Work Order ID 135103

Item ID: D407-667-105 Accept *N900040100* Setup Start *NS1*
 Revision ID: Stop *NS2*
 Item Name: Fwd Crosstube - High 407
 Start Date: 7/29/2015 Start Qty: 1.00 *1* Cust Item ID:
 Required Date: 8/12/2015 Req'd Qty: 1.00 *1* Customer:
 Reference:

DART AEROSPACE LTD		Work Order:	135103
Description: Crosstube High Fwd (407)		Part Number:	D407-667-105
Inspection Dwg: D407-667-145 Rev: C		Page 1 of 1

DRAWING NO. D407-667-145	TITLE CROSSTUBE ASS'Y (407 HIGH FWD)	REV. C	DART AEROSPACE LTD ENGINEERING ORDER		D.E.O. NO. D407-667-145-C-1	SHEET NO. SHEET 1 OF 1	SCALE NTS
DRAWN <i>qp</i>	CHECKED <i>ASS</i>	MFG. APPR. <i>IB</i>	APPROVED <i>WD</i>		DE APPR. <i>HA</i>		
DATE 11.07.15	DATE 11.07.22	DATE 11.07.22	DATE 11/07/22		DATE 11.07.21

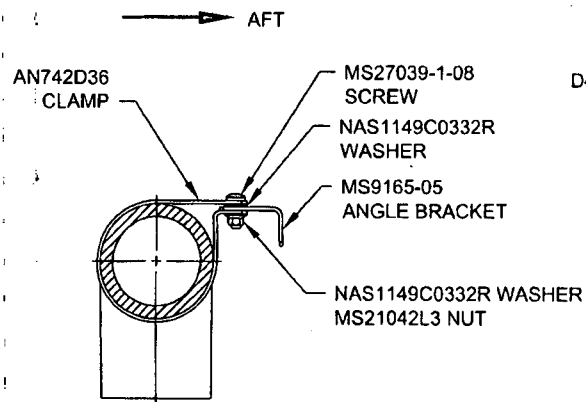
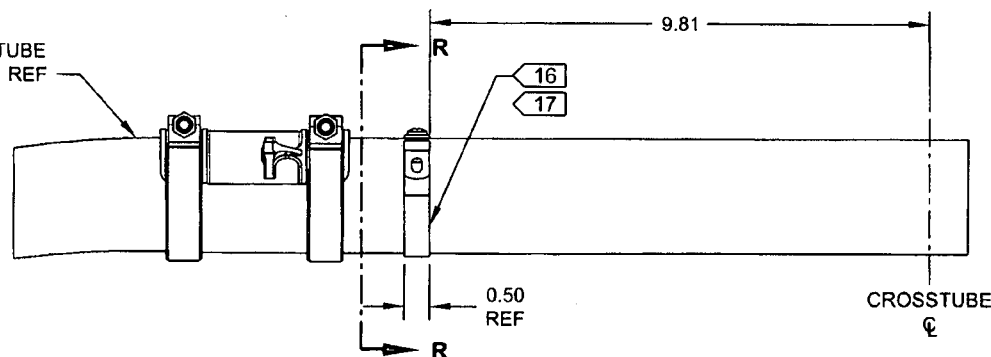
PURPOSE:

ADD ELECTRICAL GROUNDING STRAP

ITEM	QTY -145	PART NUMBER	DESCRIPTION
1	X	D407-667-145	CROSSTUBE ASSEMBLY (407 HIGH FWD)
10	2	AN742D36	CLAMP
11	2	MS9165-05	ANGLE BRACKET
12	2	MS21042L3	NUT (OR MS21042-3)
13	2	MS27039-1-08	SCREW
14	4	NAS1149C0332R	WASHER (OR AN960C10L)

- 16) MASK AREA UNDER CLAMP PRIOR TO PAINTING
- 17) SEAL EDGES WHERE AN742D36 CLAMP MEETS WITH THE CROSSTUBE USING SIKAFLEX-241/-291 OR MIL-S-8802 CLASS B2 OR PROSEAL 890 SEALANT
- 18) PERFORM RESISTANCE CHECK TO ENSURE MAX RESISTANCE IS 10 MILLIOHMS
